## Access Compliance Report Public Rights-of-Way (Curb Ramps)

Intersection ID: 51704Main Street: IKEA\_BVCross Street: BROOKSIDE\_LNLocation: WADA ID: 3D336406F8B6Ramp Type: PerpInitial Pass/Fail: FailOverall Compliance: NoSeverity Score: 10

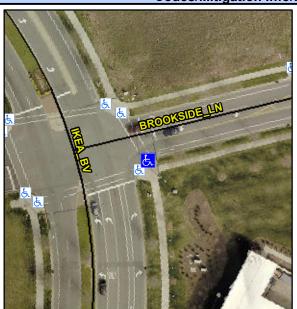
Possible Solutions:	<u>c</u>
Remove & Replace Entire Ramp.	
	N
	N
	N
	N
	N
Surveyor Notes:	N
N/A	N
	N
	N
	N
PROW/ADA:	N
Not Found, R304.5.1, R304.5.3	N
	N
	N
	N

Field Measurements/Component Compliance						
Compl	liance Description	Data	Comp	liance Description	Data	
N/A	Ramp Length (in)	107.0	Yes	Ramp Slope (%)	7.2	
No	Ramp Width (in)	47.0	No	Ramp XSlope (%)	4.1	
N/A	Flare Type LT	N/A	N/A	Flare Type RT	N/A	
N/A	Flare Slope LT (%)	N/A	N/A	Flare Slope RT (%)	N/A	
N/A	Flare Traversable LT?	N/A	N/A	Flare Traversable RT?	N/A	
N/A	Landing Length (in)	N/A	N/A	DWS Provided?	N/A	
N/A	Landing Width (in)	N/A	N/A	DWS Contrast?	N/A	
N/A	Landing Slope (%)	N/A	N/A	DWS Length (in)	N/A	
N/A	Landing X Slope (%)	N/A	N/A	DWS Full Width?	N/A	
N/A	Landing Curb? (Y/N)	N/A	N/A	DWS Offset (in)	N/A	
N/A	Shared Landing?	N/A				
N/A	Gutter Ponding?	N/A	N/A	Gutter Slope (%)	N/A	
N/A	Gutter Lip Ht (in)	0.5	N/A	Gutter X Slope (%)	N/A	
N/A	Painted X Walk1?	Yes	N/A	Painted X Walk2?	N/A	
	X Walk 1 Direction	To NW		X Walk 2 Direction	N/A	
N/A	X Walk 1 Width (in)	95.0	N/A	X Walk 2 Width (in)	N/A	
	X Walk 1 Slope (%)	0.6		X Walk 2 Slope (%)	N/A
